ANN ARBOR HISTORIC DISTRICT COMMISSION

Staff Report

ADDRESS: 300 Detroit Street, Application Number HDC19-004

APPLICATION: The applicant seeks after-the-fact HDC approval to install a vapor mitigation system on the front of the building, facing Detroit Street.

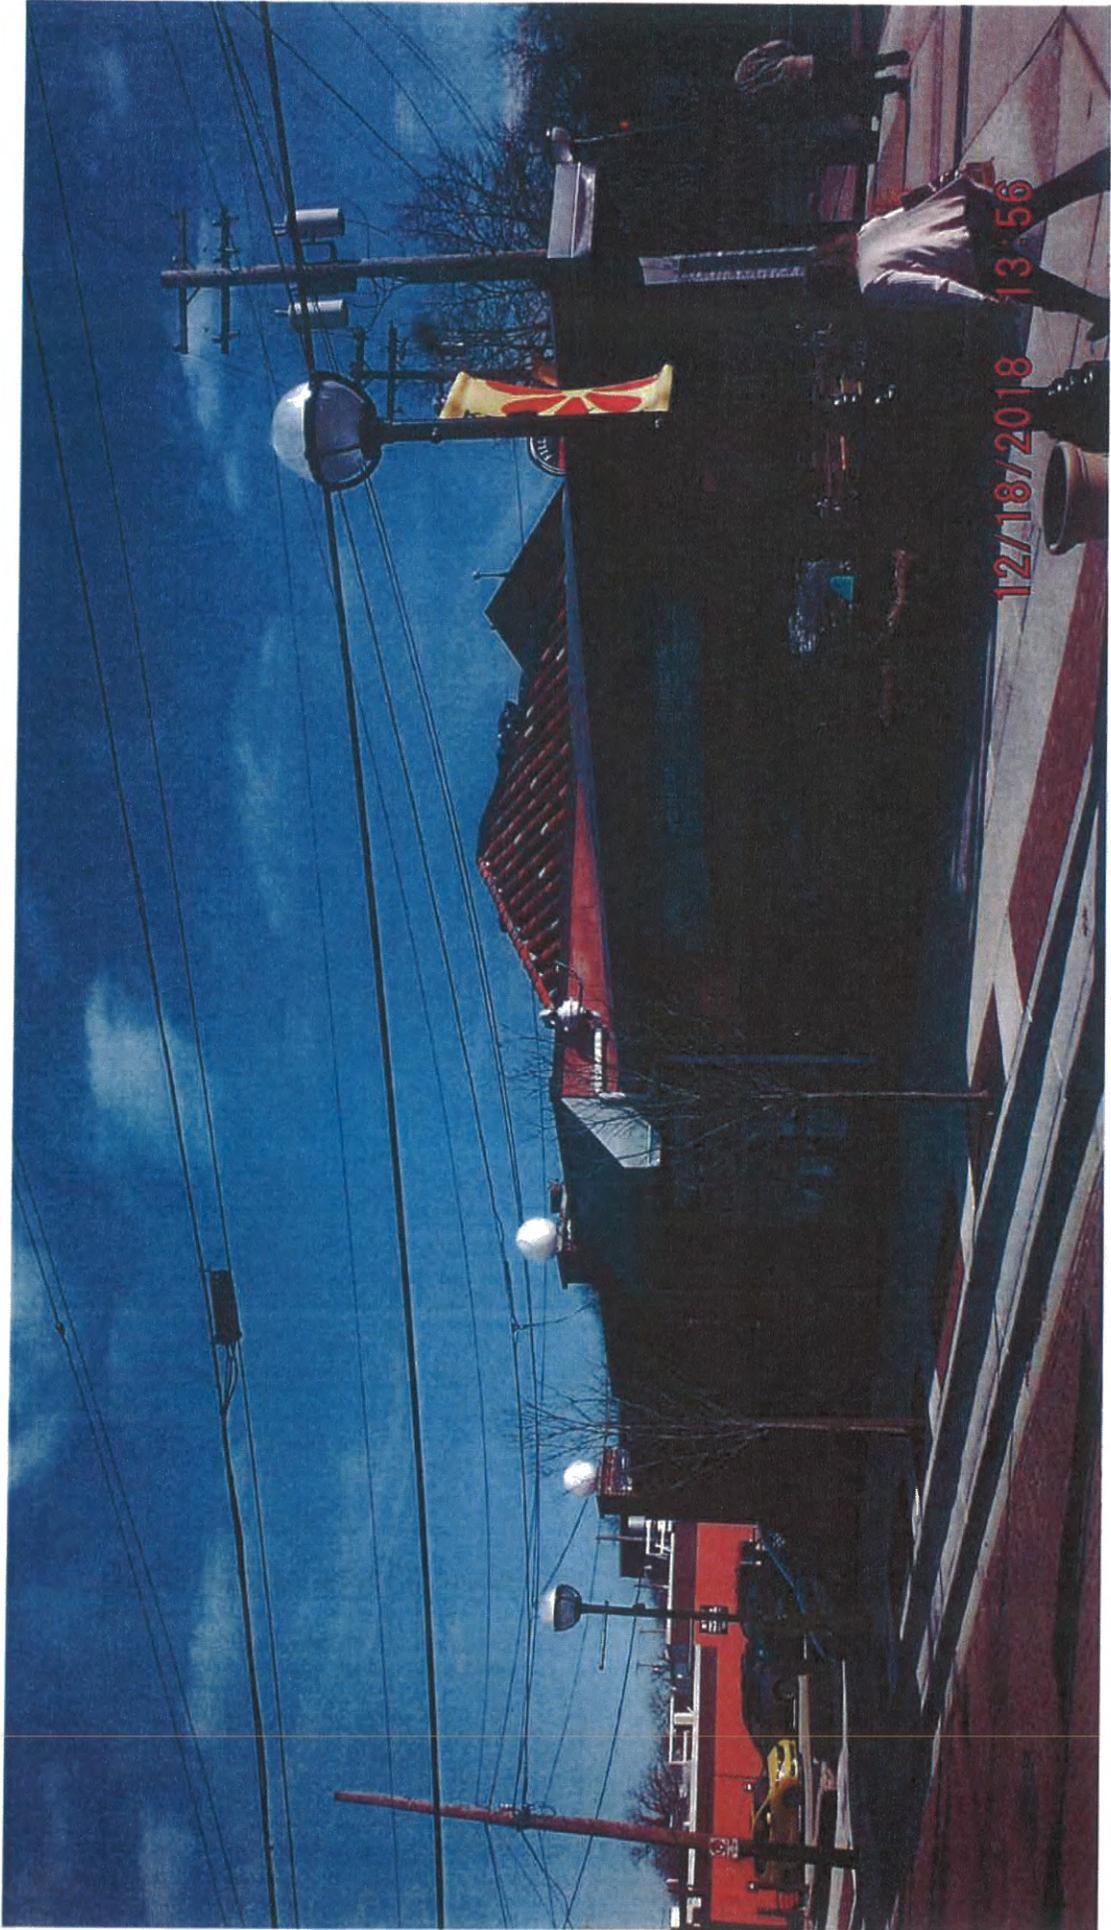
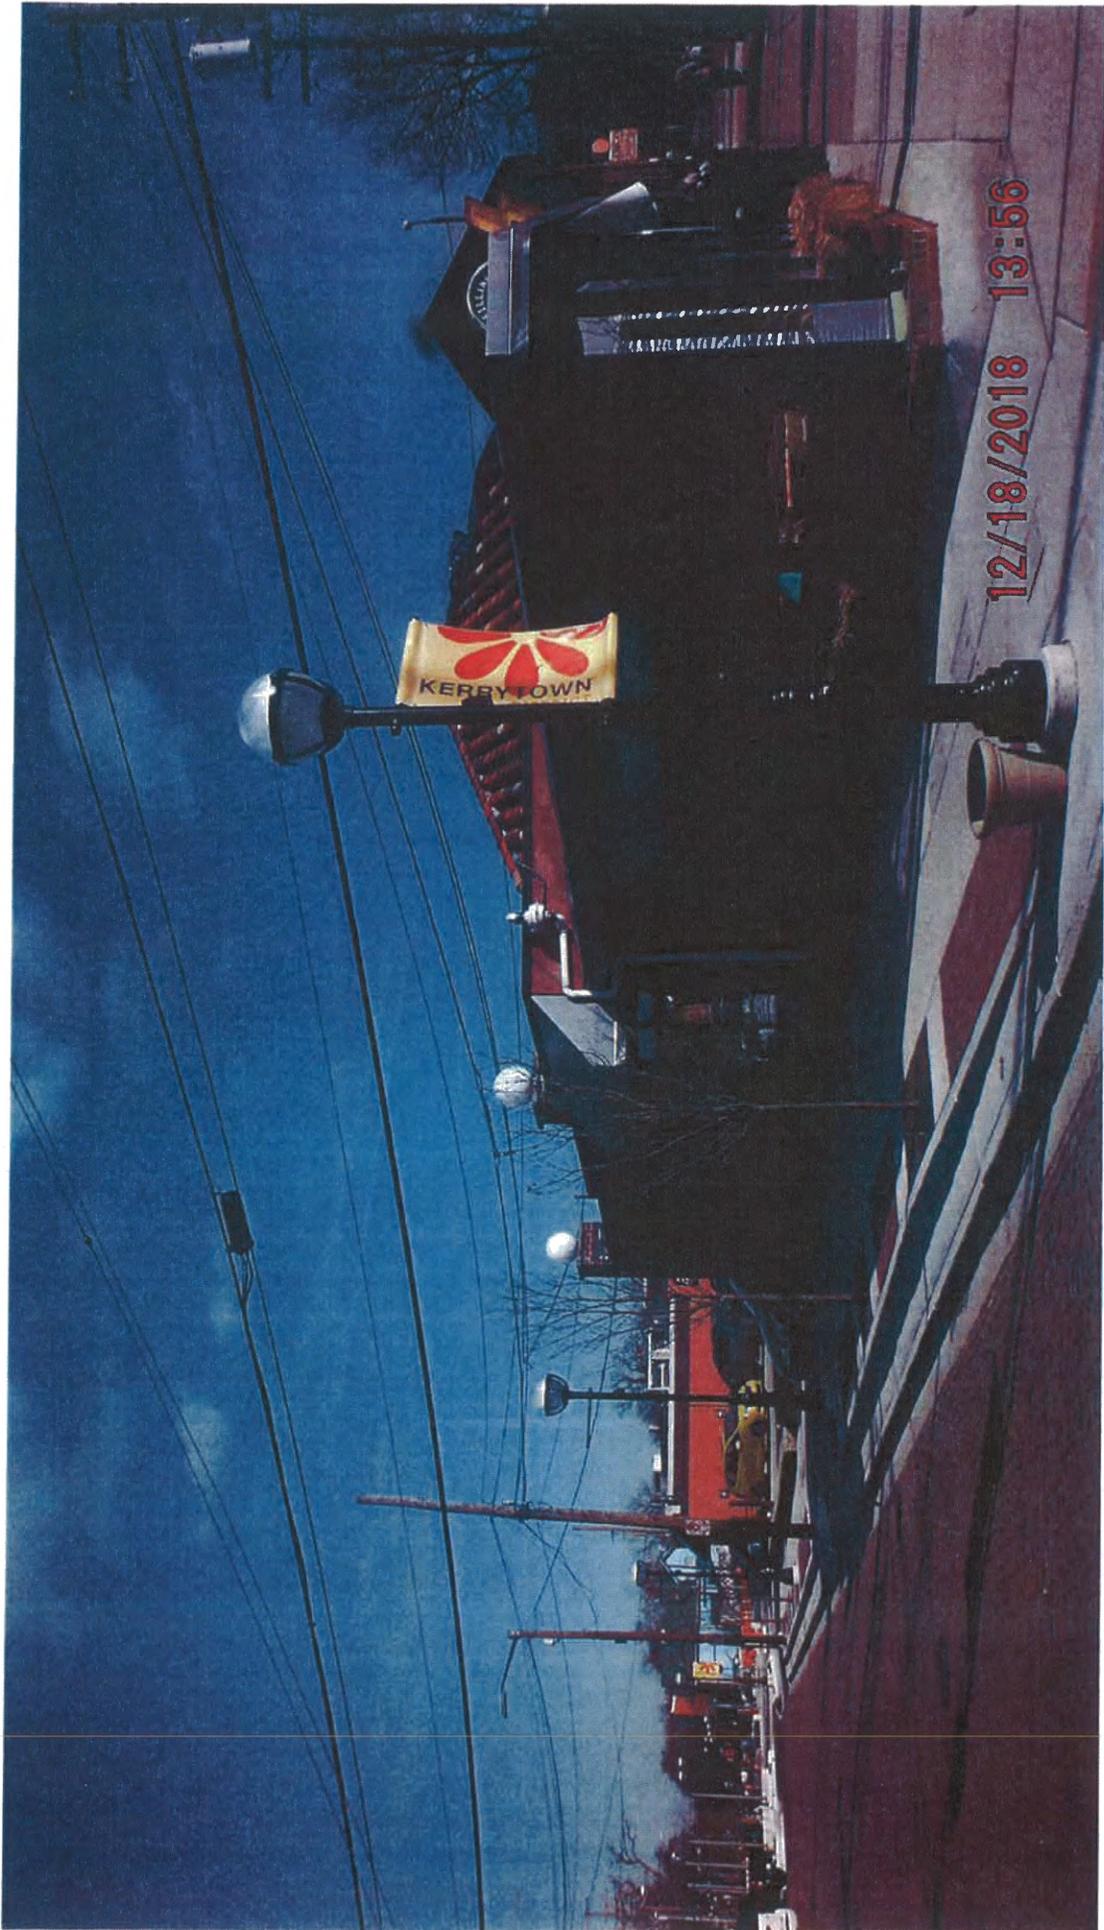
Staff suggests the commissioners take note of the location of the black metal post supporting the canopy over the outdoor patio. Currently the PVC piping wraps around the base of that post and continues in front of it up the wall. Routing the PVC behind the post and painting it black would be much less conspicuous. Similarly, note that the historic tile roof of the building is extended by several feet by a flat roof surrounded by a low parapet. The mechanical unit for the vapor mitigation is currently mounted on the street-facing side of this parapet. If the PVC pipe is routed through that street-facing side of the parapet into the building, then out through the flat roof, the mechanical unit could be relocated behind the parapet and the piping would be inconspicuous. There may also be other ways to make the vapor mitigation unit less conspicuous and more appropriate, while meeting the manufacturer's installation specifications.

The installation of the vapor mitigation unit alters the front façade of the building, and changes the character of the property along Detroit Street and when seen from other nearby streets.

This exterior alteration is not compatible with the architectural features of the building, and compromises the property's historic integrity and the integrity of the adjacent historic districts.

5. The work does not meet the *Ann Arbor Historic District Design Guidelines* for Mechanical Equipment because it is on the exterior of the building, visible from the street.

6. Staff recommends denial of this application. The location on the front façade of a historic commercial building is inappropriate and disruptive to the building and the neighborhood. The work is visibly incompatible with the building and the historic district, and does not meet the *Secretary of the Interior's Standards for Rehabilitation*, the *Secretary of the Interior's Guidelines for Rehabilitation*, or the *Ann Arbor Historic District Design Guidelines*.

The suction point of the system was installed through the concrete patio slab in order to insure sub slab communication to the test point location at the tip of the patio. The system had to be located next to the building itself to provide a stable mounting location to support the system, with the fan mounted above the patio roof line and the exhaust above the building roof. (Pictures of system attached)

The current suction point placement got the best performance result to impact the test point near the end of the patio slab as required to provide adequate communication. The suction point could not be placed inside the building as the slab inside the building and the patio slab are two separate slabs divided by the buildings foundation footer, which will not allow sub slab air flow from the patio area to the building slab. The system was placed where it is because it was the best location to do the job it was designed for, it was not placed there for any other reason.
